**CORRESPONDENCE COVER SHEET  
WASTE PERMITS DIVISION  
TEXAS COMMISSION ON ENVIRONMENTAL QUALITY**

Date: April 24, 2026  
 Facility Name: Northwest Transfer Station  
 Permit or Registration No.: 40348

Subject: **NOD 3** Response Tracking No. 32527669  
 Northwest Transfer Station MSW Type V Registration Application No. 40348  
 14421 Sommermeyer Street, Houston, Harris County, Texas 77041

**NOD 3 and Responses**

SHEET TITLE:  
**CONSTRUCTION PHASING PLAN**

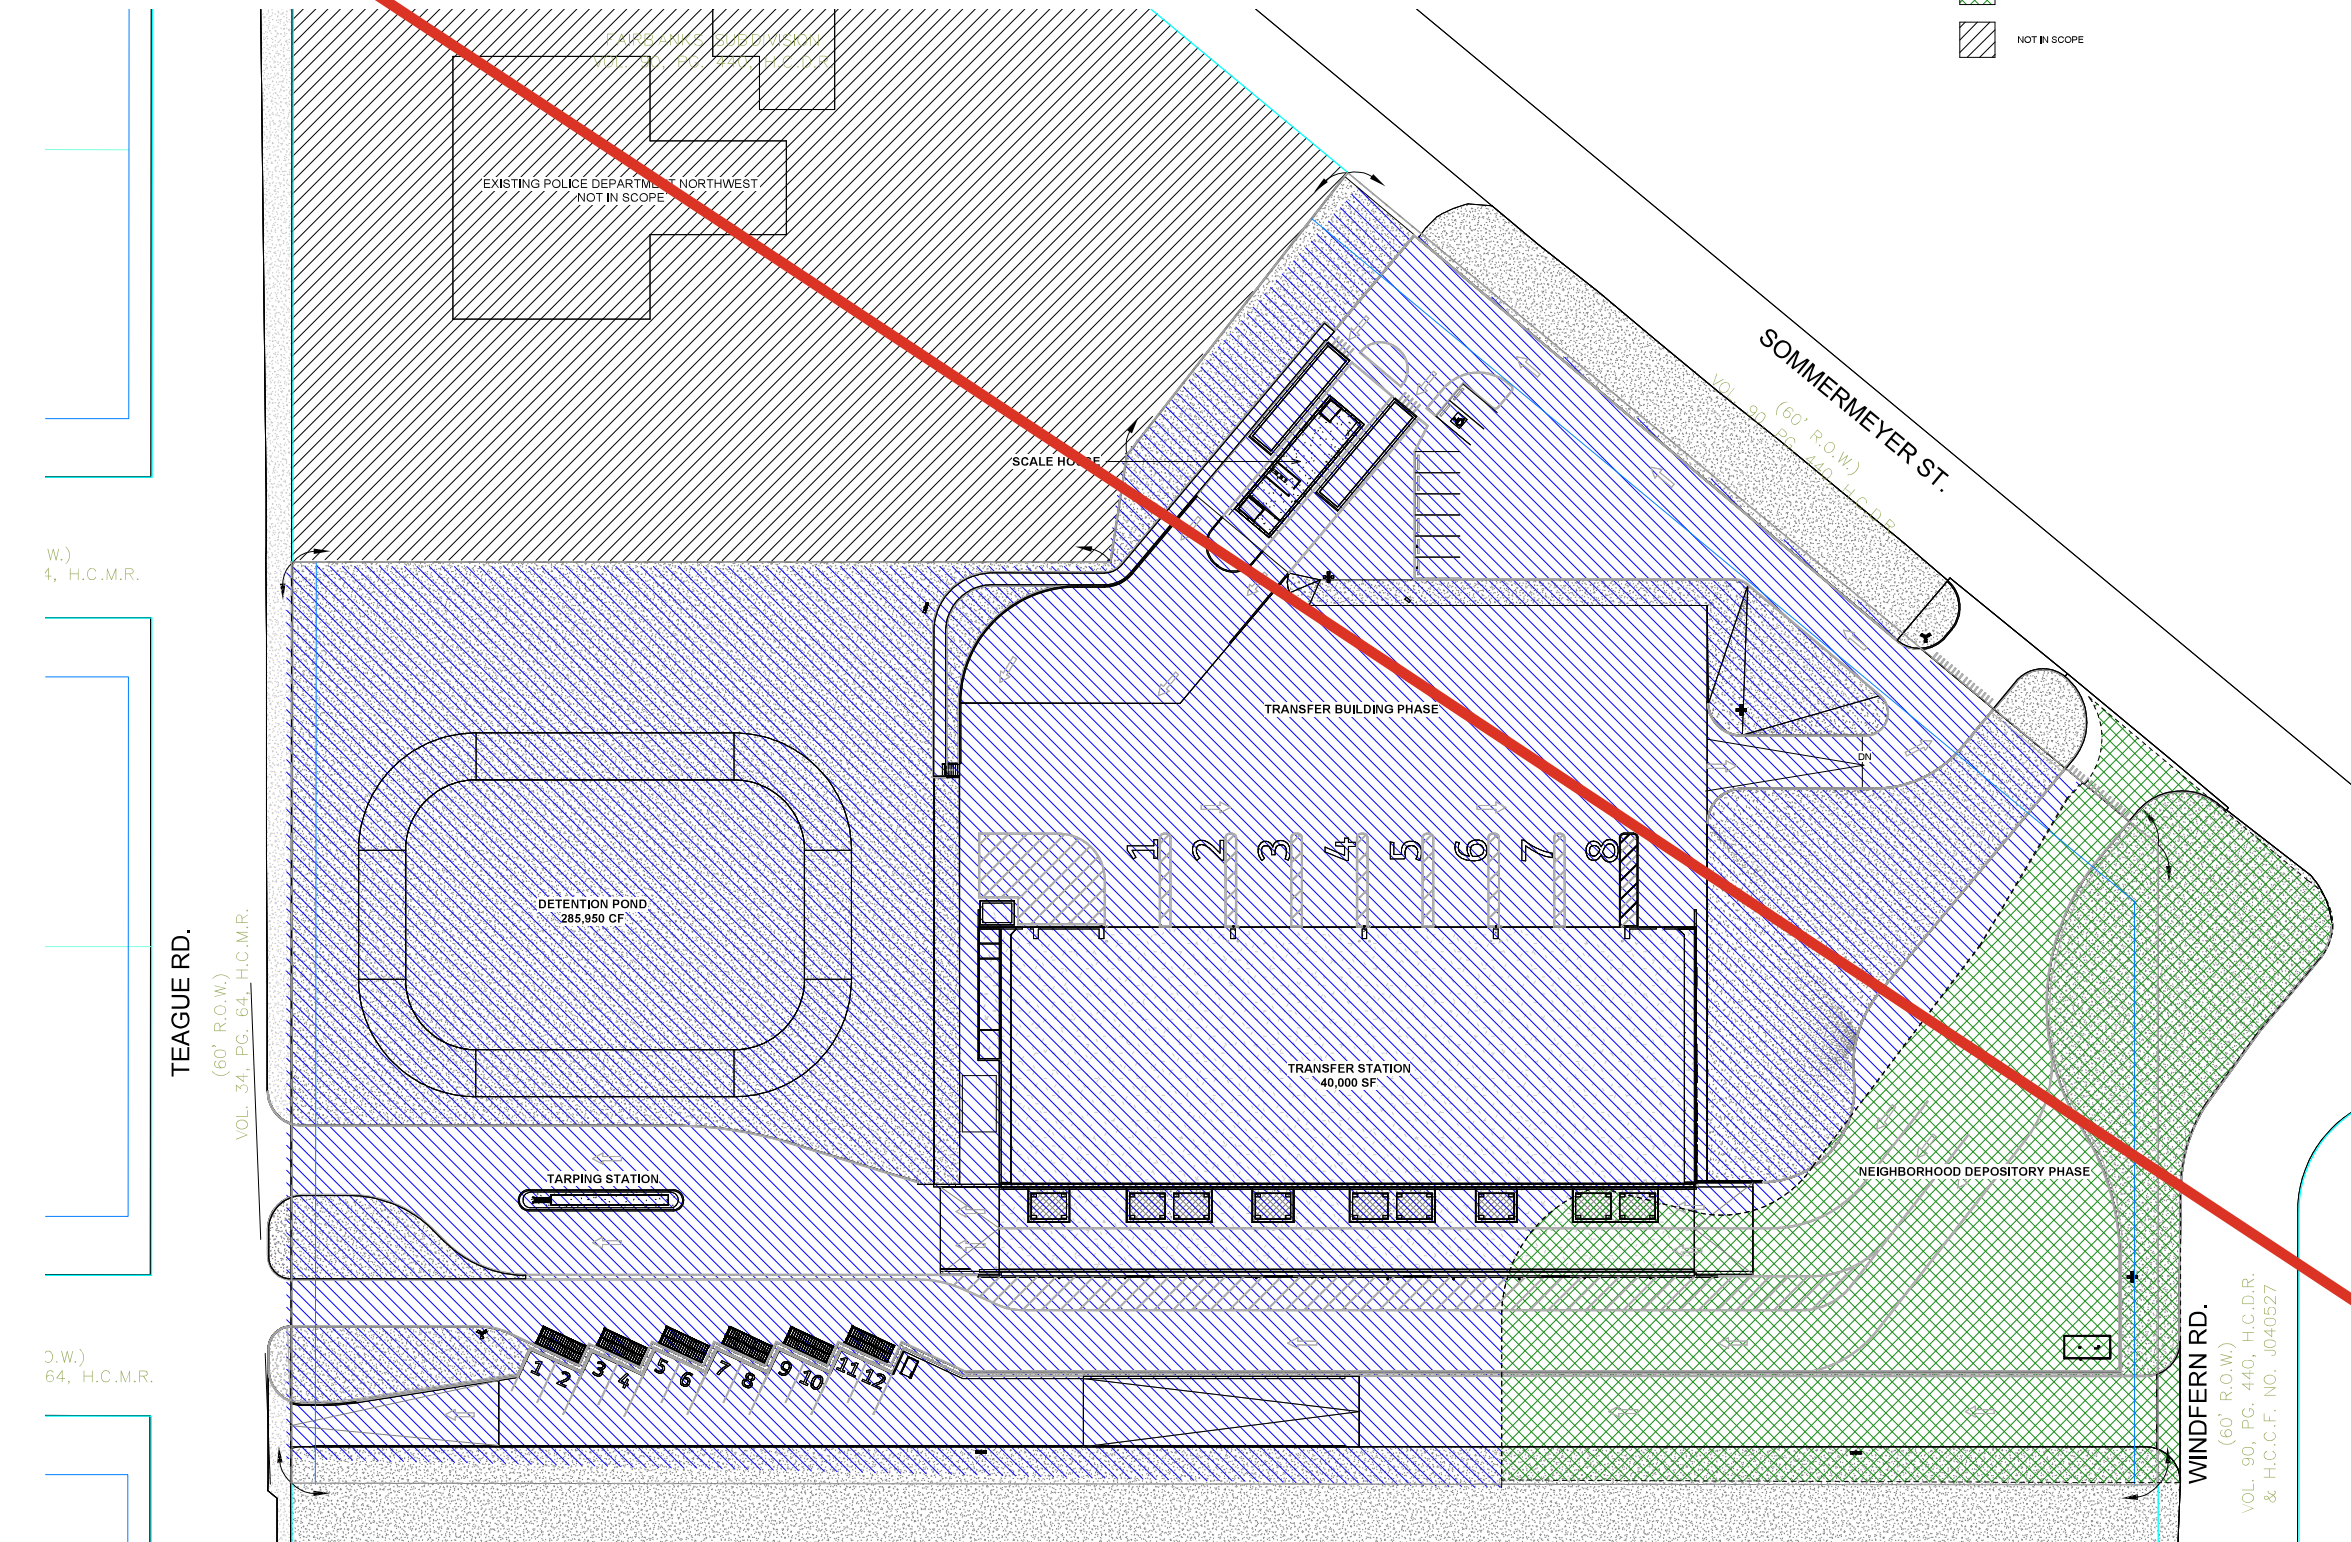
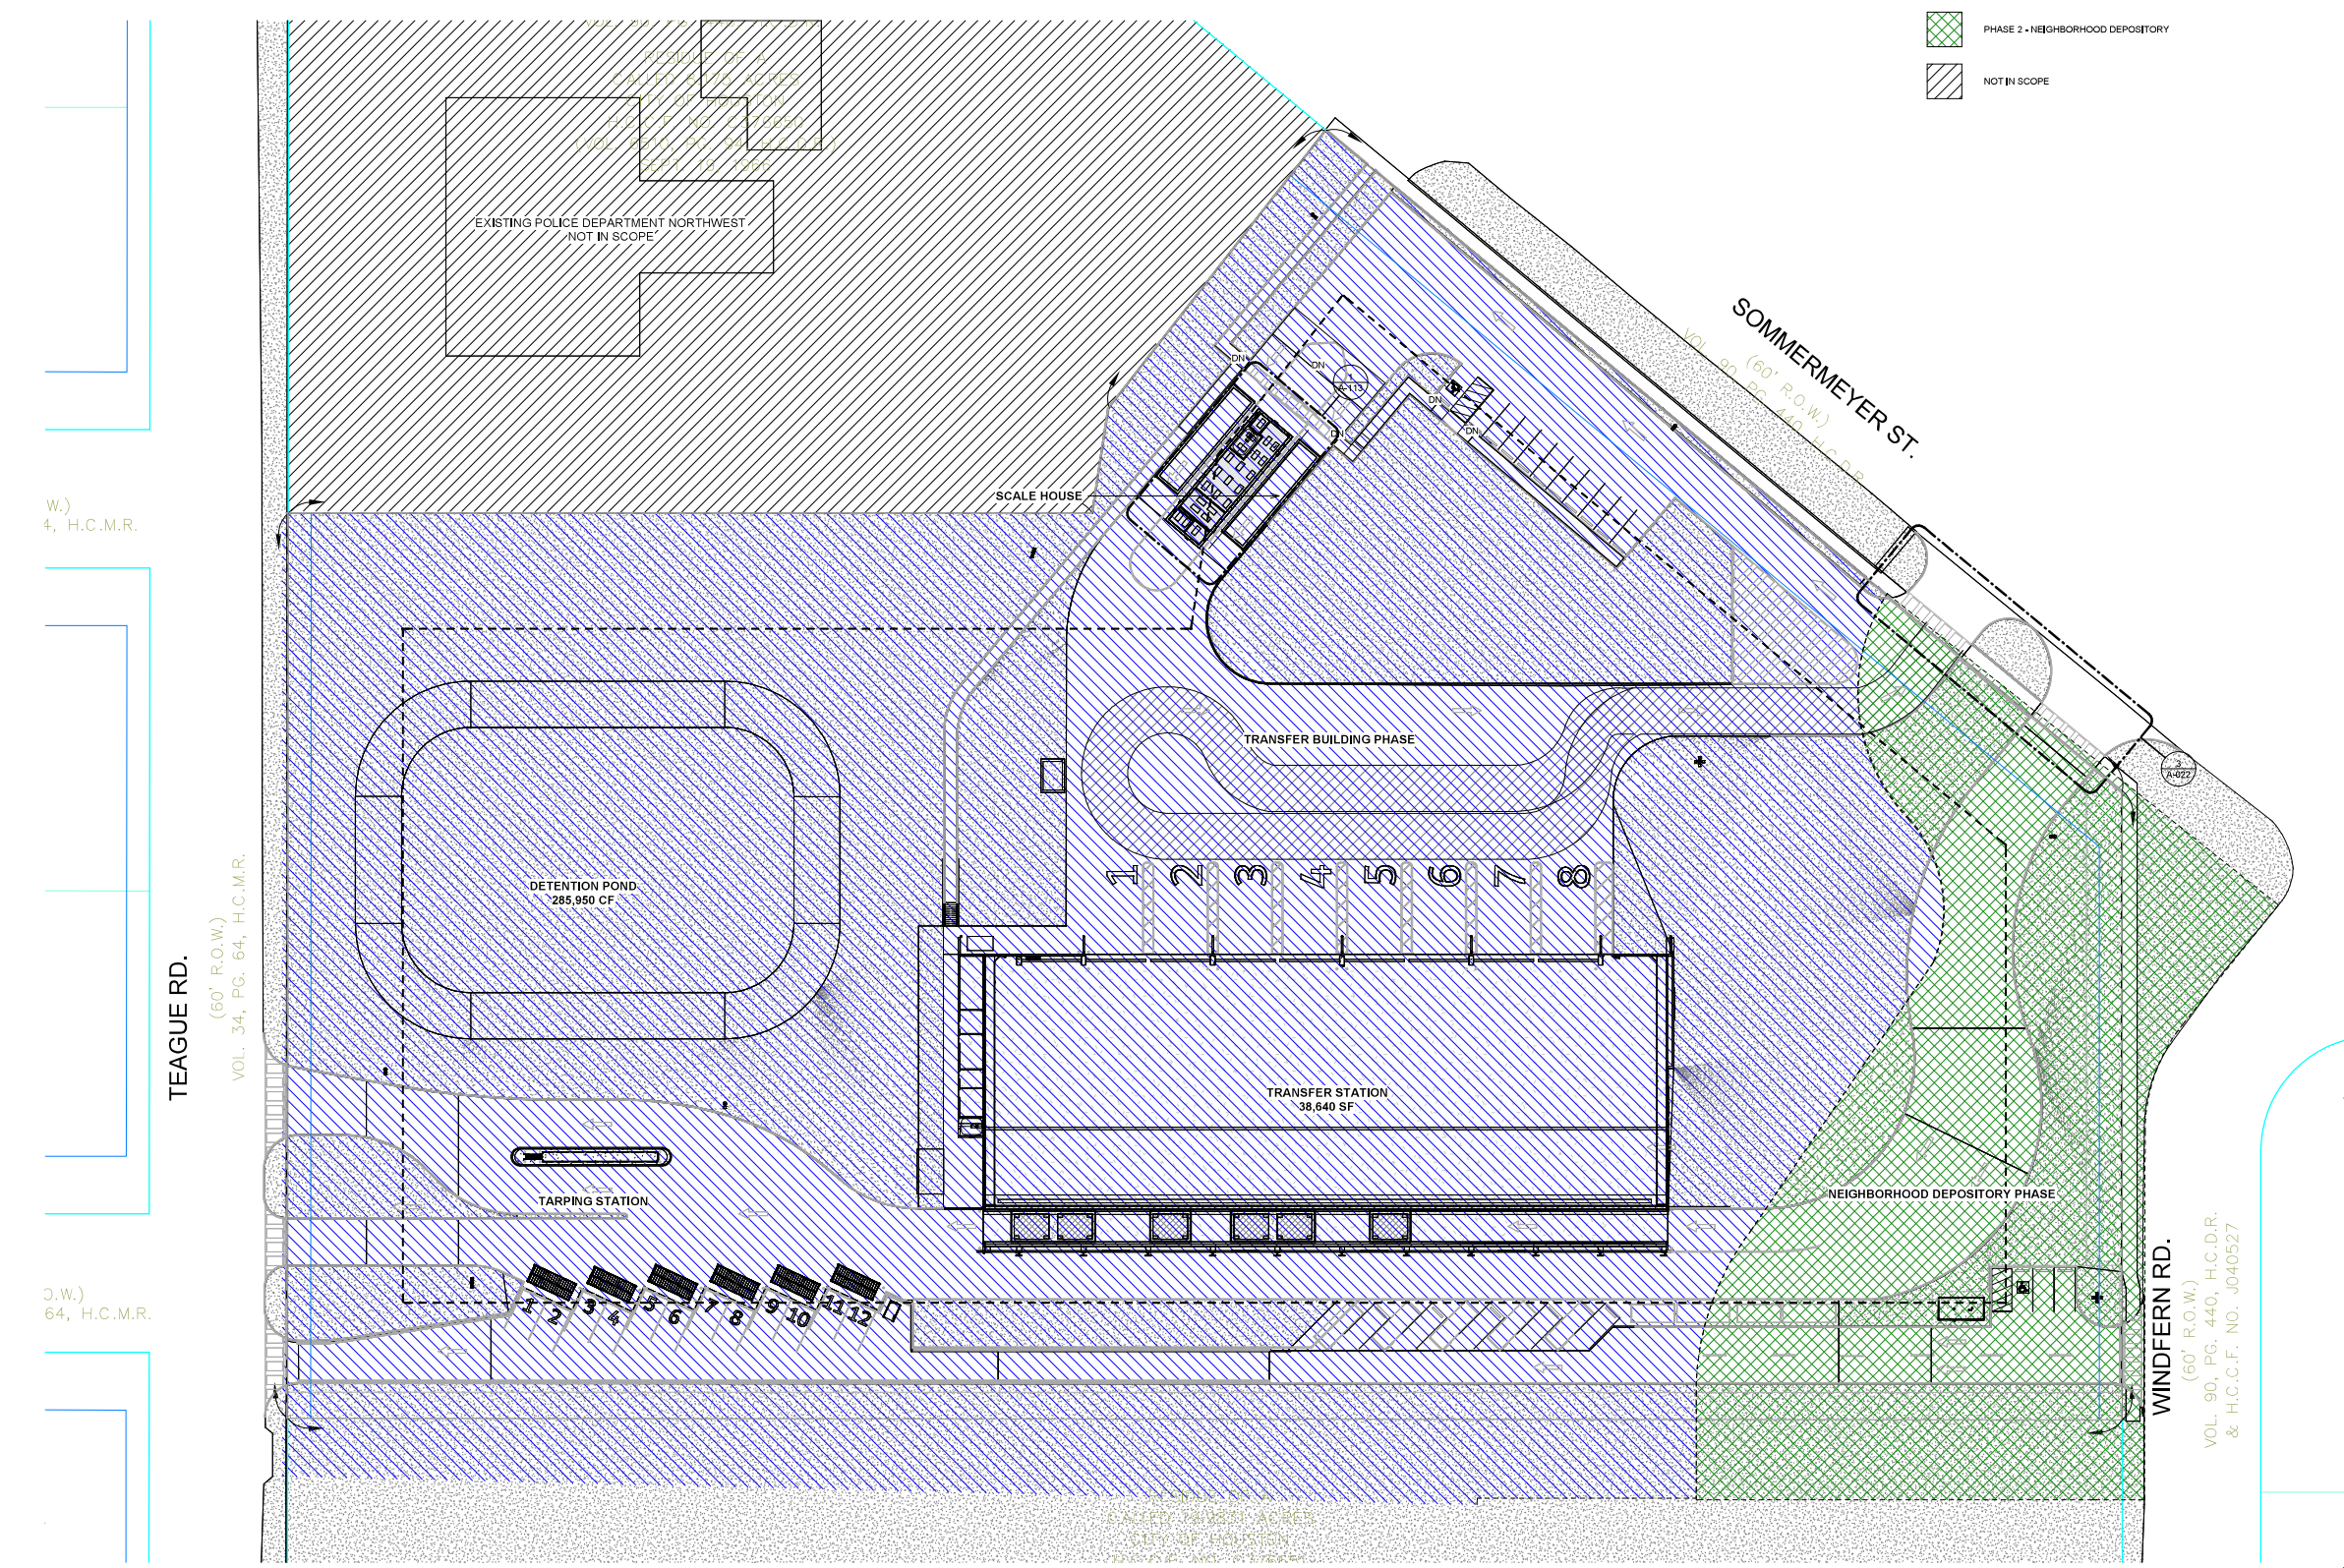
T2		General		Ambiguous	Attachment II-2 Figure 9A, Construction Phasing Plan (G-220), also found in Attachment III-1 Page 4, indicates a two-phase construction plan. Provide a brief discussion of the construction phases, including any changes made to the citizens' collection station currently registered under MSW ID No. 40133. Changes made to the citizens' collection station after the registration is issued could require a registration modification before changes are made.	<p>A discussion of the construction phases was added to Part IV Section 1.1.</p> <p>A description of changes made to the Depository (Citizen's Collection Station) was added to Part IV Section 7.0.</p>
T3	101	Part I	330.59(f)(4)	Incomplete	<p>(a) Provide previous affiliations with other organizations engaged in solid waste activities for the principals and supervisors associated with the proposed solid waste registration.</p> <p>(b) A formatting issue was found in Section 2.5 of Parts I/II. The TAC reference to 30 TAC 330.59(f)(4) includes a "±" in place of, "f." Please correct the formatting issue.</p>	<p>(a) We replaced the three officers and supervisors listed in the original application with three other officials and included their previous affiliations with other organizations engaged in solid waste activities (employers, job titles, and time periods in each job).</p> <p>(b) The "±" in Parts I/II Section 2.5 was replaced with an "f."</p>

Construction Phasing is shown on Attachment II-2 Figure 9A and Attachment III-1 Page 4 Sheet G-220. Following demolition of existing structures and pavements, the construction phases will include:
